Application No.	Applicant(s)
Notice of Allowability	10/785,000	CHEN, CHENG WEN
	Examiner	Art Unit
	Melody M. Burch	3683
The MAILING DATE of this communication appears on the cover sheet with the correspondence addressAll claims being allowable, PROSECUTION ON THE MERITS IS (OR REMAINS) CLOSED in this application. If not included herewith (or previously mailed), a Notice of Allowance (PTOL-85) or other appropriate communication will be mailed in due course. THIS NOTICE OF ALLOWABILITY IS NOT A GRANT OF PATENT RIGHTS. This application is subject to withdrawal from issue at the initiative of the Office or upon petition by the applicant. See 37 CFR 1.313 and MPEP 1308.  1. ☑ This communication is responsive to amendment filed 8/2/05.  2. ☑ The allowed claim(s) is/are 4 and 5.  3. ☑ Acknowledgment is made of a claim for foreign priority under 35 U.S.C. § 119(a)-(d) or (f).  a) ☑ All b) ☐ Some* c) ☐ None of the:  1. ☑ Certified copies of the priority documents have been received.  2. ☐ Certified copies of the priority documents have been received in Application No. ☐ Copies of the certified copies of the priority documents have been received in this national stage application from the In

FIG. 3

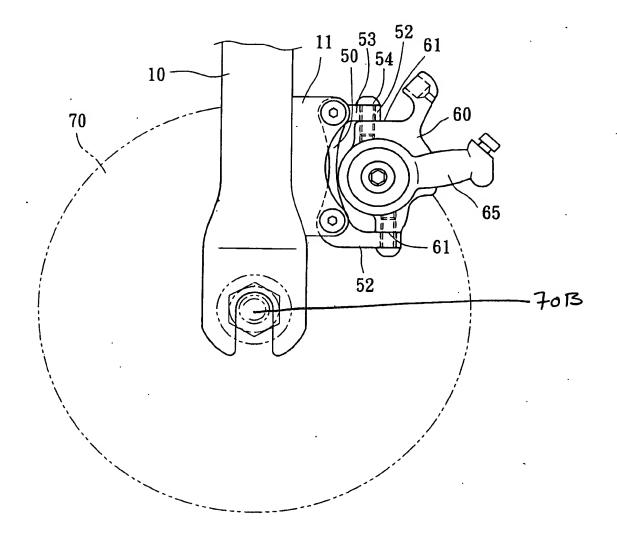
- 2. The following changes to the drawings have been approved by the examiner and agreed upon by applicant: in figure 3 the wheel axle has been labeled with reference character --70B-- to correspond to the changes in the specification as set forth in the marked-up copy of figure 3 attached with this Examiner's amendment. In order to avoid abandonment of the application, applicant must make these above agreed upon drawing changes.

In line 7 of pg. 7 of the specification the phrase "wheel axle" has been changed to --wheel axle 70B--;
